GENERAL MOTORS
DCS7590
URGENT - DISTRIBUTE IMMEDIATELY

Subject: UPDATE: N262570770-02 – Service Update
Radiator Thermal Break Tabs
Updated Warranty Information and Service Procedure

Models: 2023 – 2025 Cadillac XT5
2023 – 2025 Cadillac XT6
2024 – 2025 Chevrolet Blazer

N262570770 Radiator Thermal Break Tabs

7213566

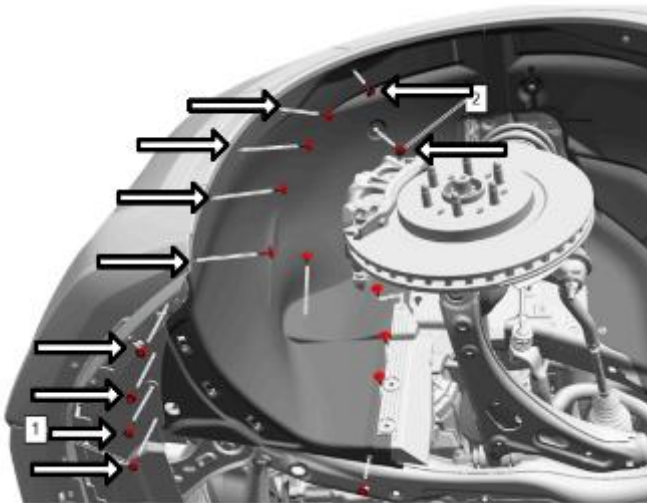
8. Carefully pull back the sides of the Radiator Air Upper Baffle and cut the thermal break tabs (4 in total) on both the left and right hand sides of the radiator with side cutters.
9. Reassemble in the opposite order of disassembly.
